November 2024 | Final Environmental Impact Report State Clearinghouse No. 2023120006

Irving Middle School Major Modernization Project

Comment Letters and Responses to Comments

Photo 3: view of the south end of Irving from the cul de sac off Margeurite Street. This area of the campus is slated for renovation.

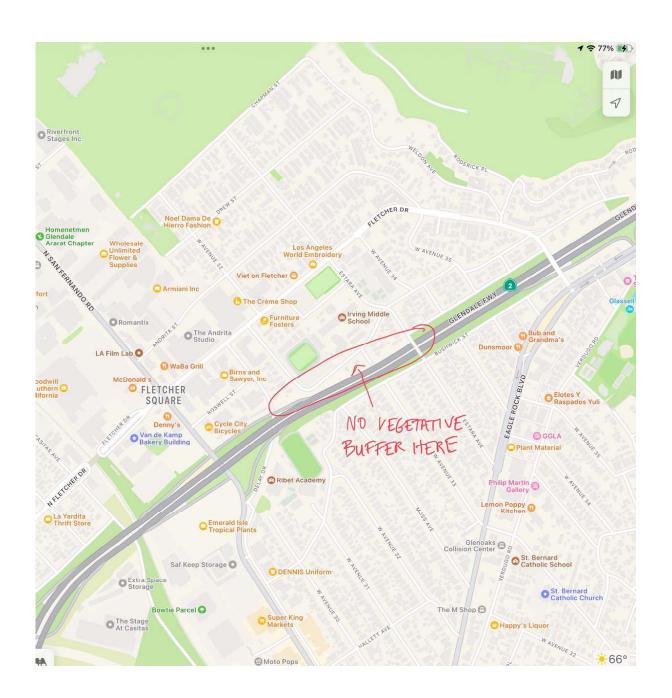
Photo 2: 7'h wall at dead end cul de sac off Marguerite Street. Unless the city reclaims some of this for a vegetative buffer, this area will remain exclusively as hardscape.

Please consider the air quality when reviewing designs to ensure that this important health consideration is included in the design directives, particularly in areas adjacent to the freeway edge.

Thank you for your comment letter with resources regarding air quality around schoolyards. A landscape buffer will be included in the design along the property boundaries impacted by the Project, including the Marguerite Street property edge. A clarification has been made to Chapter 2, *Project Description*, of the Draft EIR (see Chapter 8, *Errata*, of the Final EIR).

A clarification has been made to Chapter 2, *Project Description*, of the Draft EIR (see Chapter 8, *Errata*, of the Final EIR). to specify that the 30 percent landscape area planned for the Campus would include a vegetative buffer along Marguerite Street to reduce existing air quality effects of the Campus location within 500 feet of the SR 2 freeway. Although the proposed Project would not exceed emissions limits, this refinement to the proposed Project description would improve existing conditions.

VIEW OF 2 FREEWAY FROM ESTARA BRIDGE (LOOKING WEST)

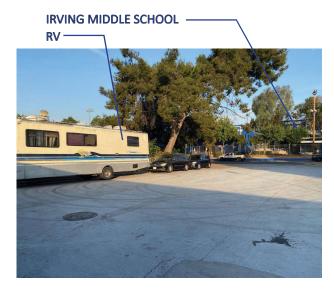
- -Irving Middle school visible at right (royal blue and white building)
- -Note the **lack of a vegetative barrier** along this portion of the freeway, **especially** at the bumped out cul de sac off of Margeurite St, where the RV is visible.
- -Possible to plant a tall vegetative barrier along the fwy edge (except at bump-out at the cul de sac)?
